Lead Local Flood Authority

Date 2nd April 2026

RE: DC/26/0366 – Land North West of Southwater

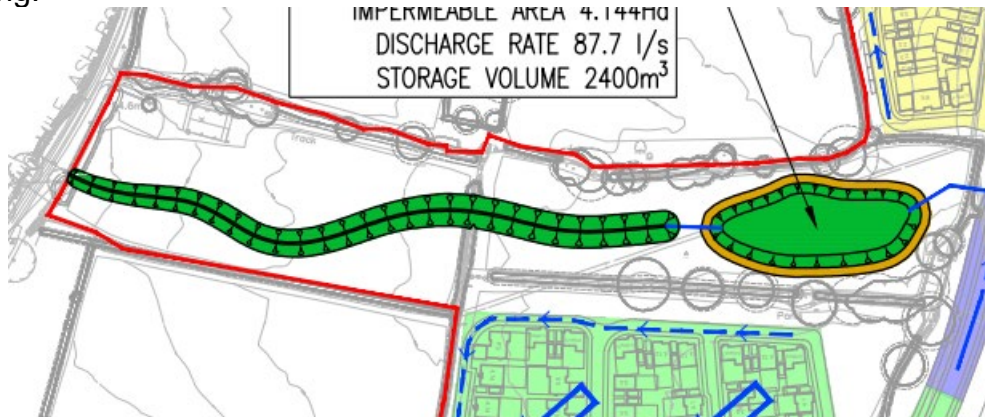
The applicant has stated that the surface water drainage is split into two catchments, with staged discharge rates for each catchment.

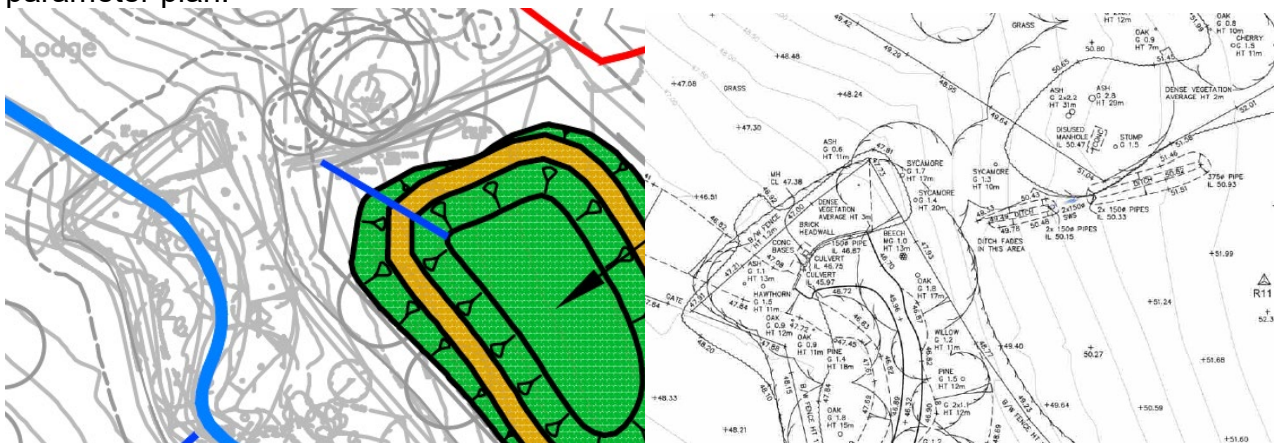
It is unclear where the swale for Basin 4 will discharge to, as the watercourse is not on the drawing.

Similarly, it appears that Basin 2 is proposed to discharge into a ditch that, based on the topographical survey, does not have onward connectivity, as there is a label “ditch fades in this area”.

Based on the information submitted it is assumed that the watercourse is culverted from the location of the ‘pond’, under Two Mile Ash Road, then the watercourse reopens within the grounds of Christs Hospital School. The details of this culvert (route, capacity and condition) and onwards connectivity of the watercourse are unknown currently and as such further investigation is required. This is to ensure that this watercourse is able to receive flows without increasing flood risk elsewhere. If it is found that the watercourse cannot receive these flows, alternatives will need to be explored at outline stage, to ensure there is a viable method of draining the north catchment. This is not something we can condition for reserved matters/detailed design stage, as if it is found that the watercourse does not have onward connectivity, this is likely to require alterations to the parameter plan.

For avoidance of doubt, the onward connectivity of all watercourses that it is proposed to discharge surface water at restricted rates to, must be demonstrated at outline stage.

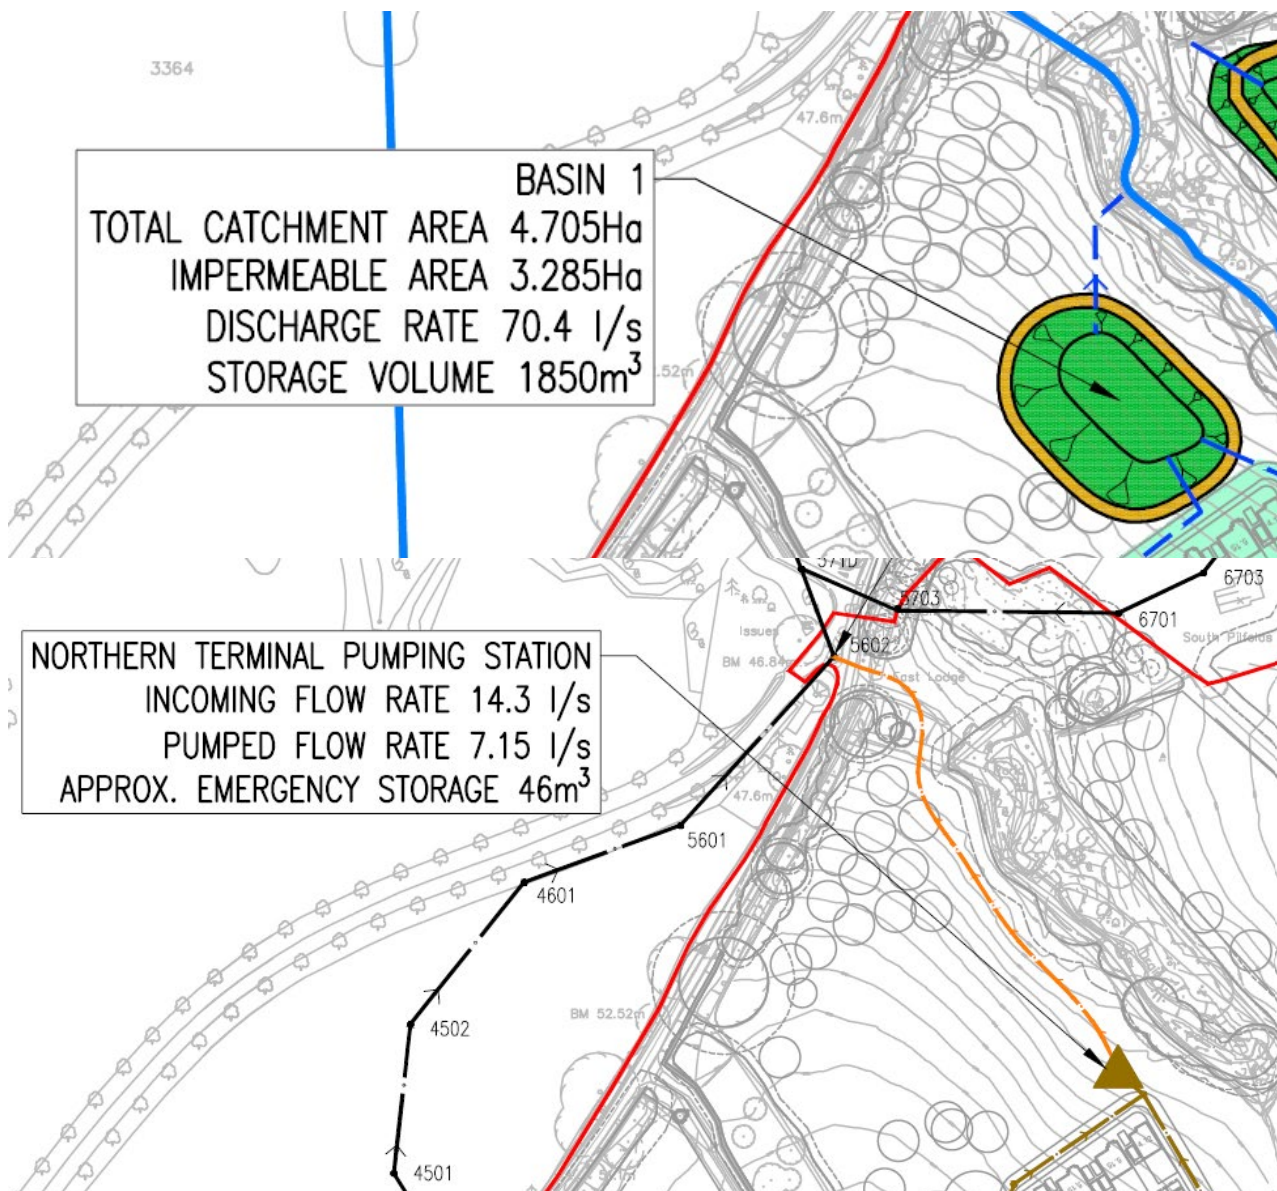
There appears to be areas which will be impermeable, which have not been considered in the current drainage strategy. For example, there is proposed to be a basin located in the area of the main secondary school building. Based on the drainage layout, it is unclear how the school area will drain.

In addition, we would disagree with 2.4.2, as there appears to be more than two ordinary watercourses within the site, as detailed in the topographical survey.

Basin 3

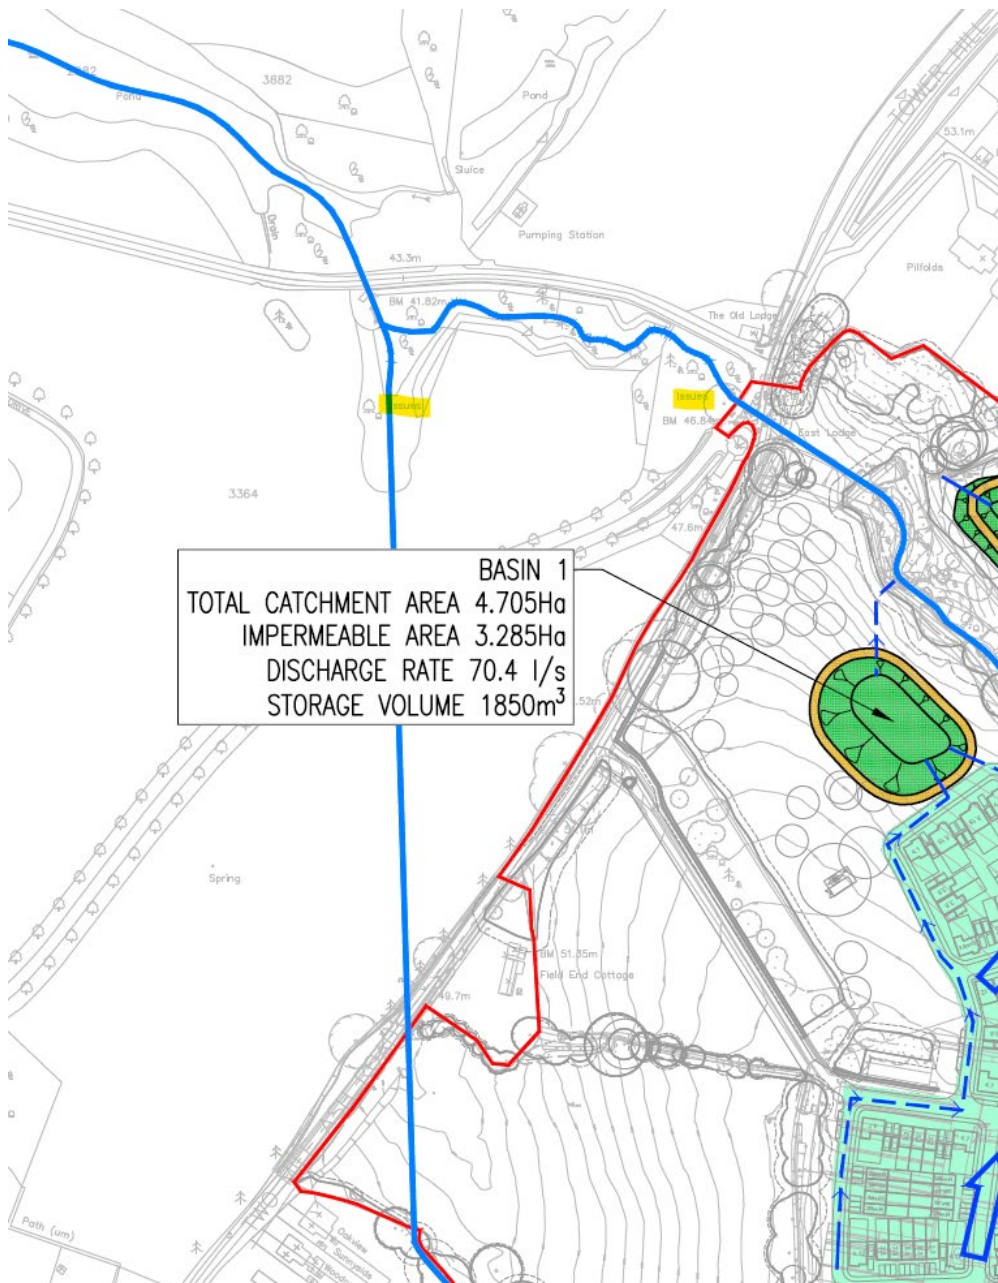
We would expect the total volume in the hydraulic calculations to correspond with the drainage layout. For example, for Basin 3, the drainage layout says the storage volume will be 425m³, whereas the calculations say 427.176m³. It is important these match.

The quality of the hydraulic calculations is poor and incredibly difficult to read. For example, see below. Due to the issues raised above, and difficulty reading the calculations, we have not completed a full review of this set of calculations, as these are likely to change.
